Steven M. Clouse WRC Headworks Enhancements Phase 2 Project
Solicitation No.: CO-00474-SM
Job No: 19-6504

ADDENDUM 1
October 29, 2021

TYPICAL DETAILS

OVERALL PLAN

9 TYPICAL SAWCUT CONCRETE REPAIR DETAIL
S-02 SCALE: NOT TO SCALE

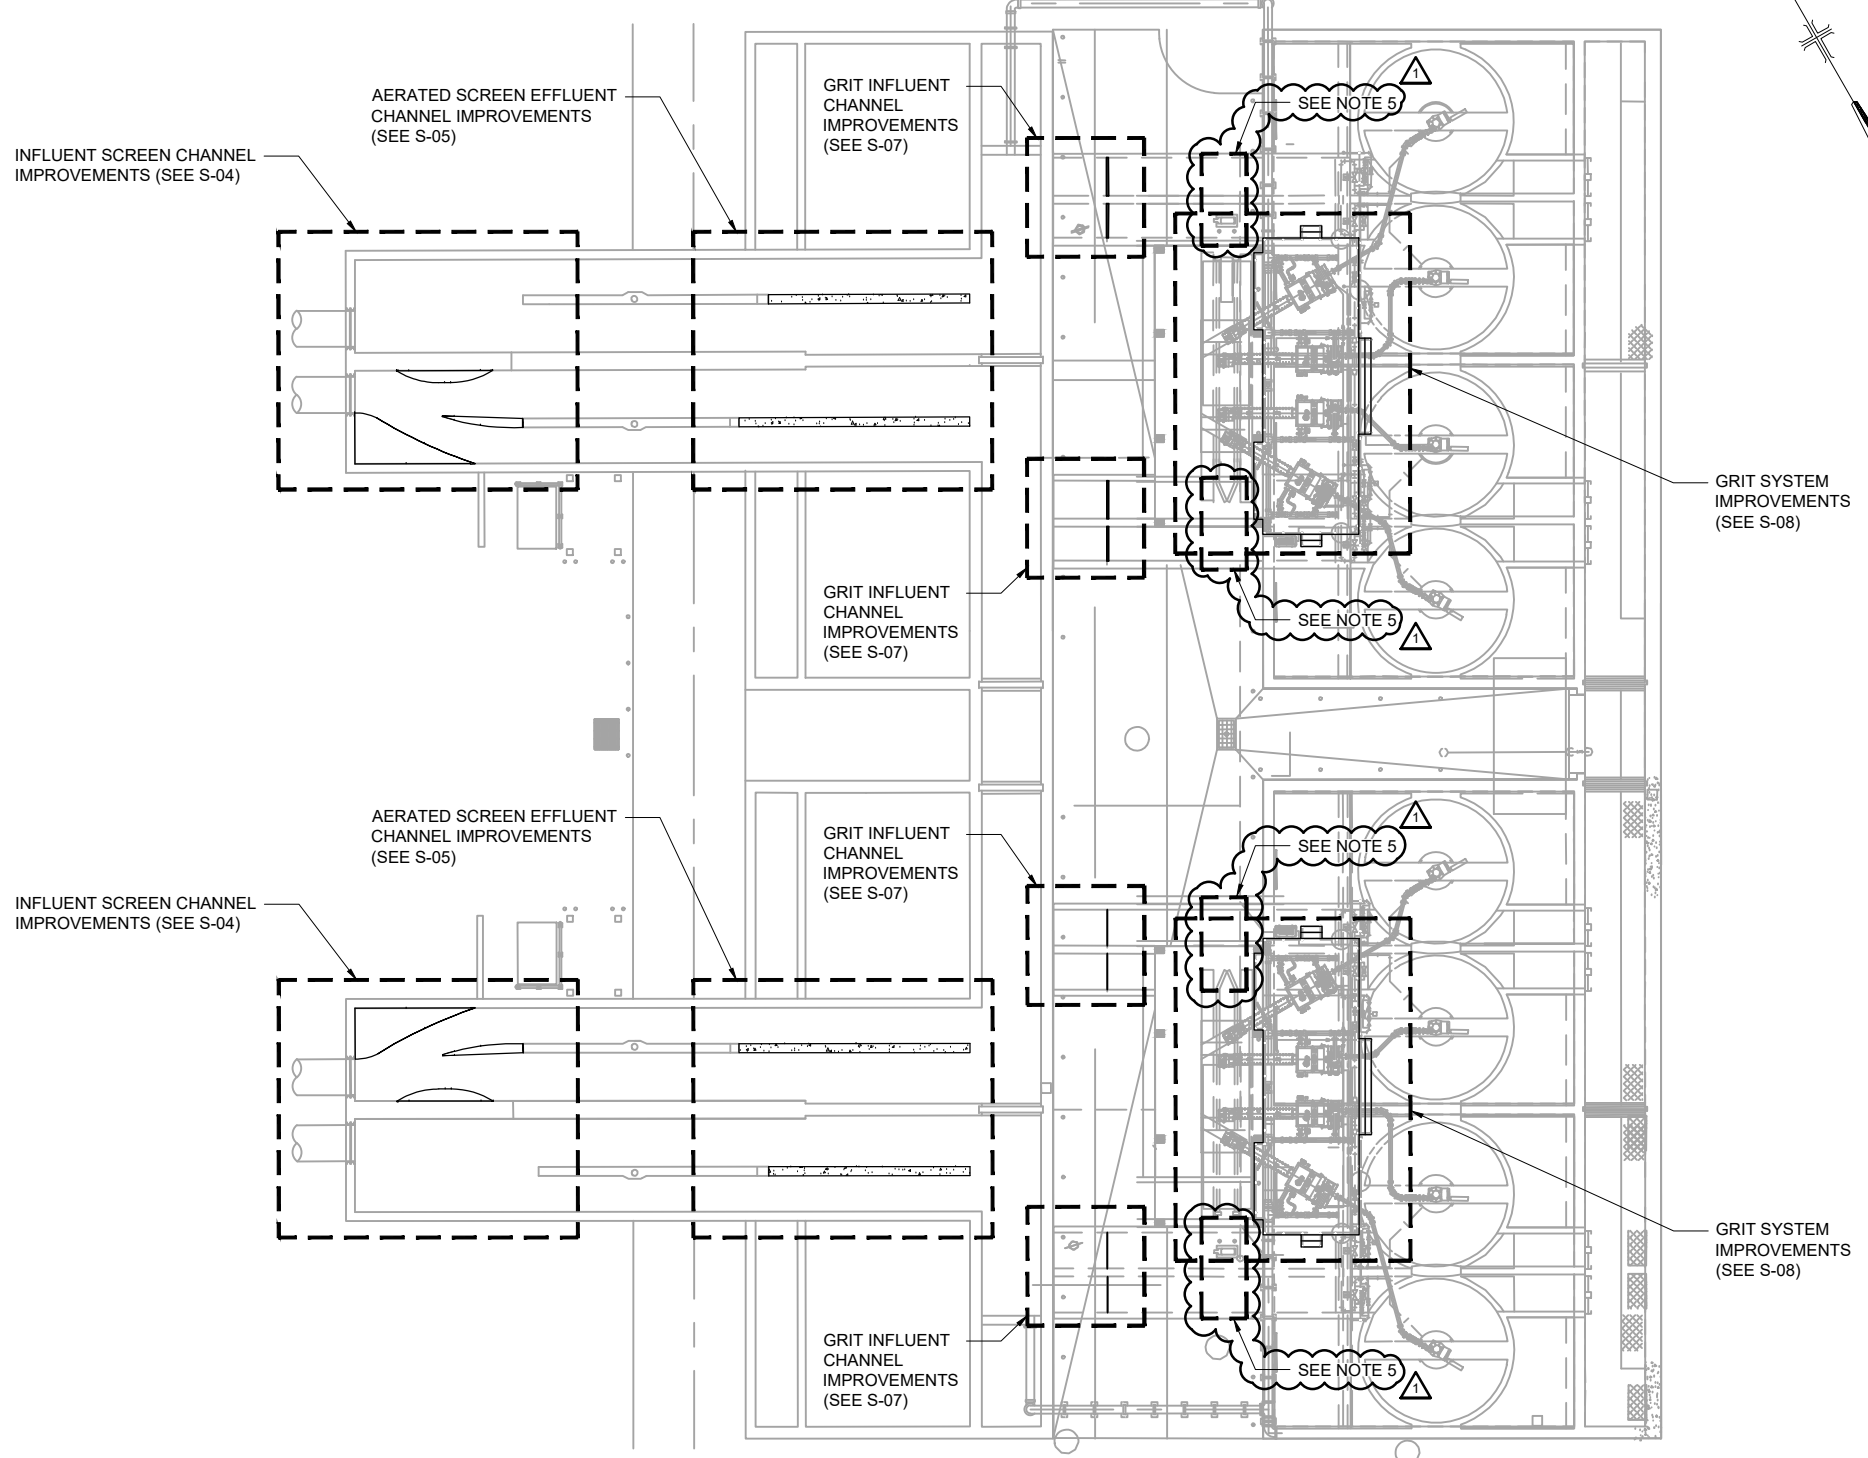
Proj. No.:	1045	1	10/1/21	ADDED DETAIL 9 (ADDENDUM NO. 1)
Designed:	I. CAULEY			
Drawn:	J. RAY			
Approved:	I. CAULEY			
File:	30036983-S-02			
Revision	Date	Description

- SAW CUT SURFACE OF EXISTING CONCRETE. WHERE NECESSARY, USE SPECIFIED SPALL REPAIR MATERIALS TO PATCH DAMAGED OR OVER CUT AREAS PRIOR TO PROCEEDING WITH SPECIFIED COATING SYSTEM.
- ROUGHEN EXISTING SURFACE AS REQUIRED.
- LIBERALLY APPLY A MINIMUM OF TWO COATINGS OF THE CORROSION INHIBITOR TO ALL SURFACES. CORROSION INHIBITOR SHALL BE SIKAFERROGARD 903 OR APPROVED EQUAL.
- AFTER ADEQUATE DRYING TIME, LOW-PRESSURE WASH ALL SURFACES TO REMOVE DEPOSITED FILM FROM CORROSION INHIBITOR.
- APPLY 2 COATS OF PROTECTIVE SLURRY MORTAR. SLURRY MORTAR SHALL BE SIKATOP SEAL 107 OR APPROVED EQUAL.
- APPLY ALL MATERIALS IN ACCORDANCE WITH MANUFACTURER'S RECOMMENDATIONS.
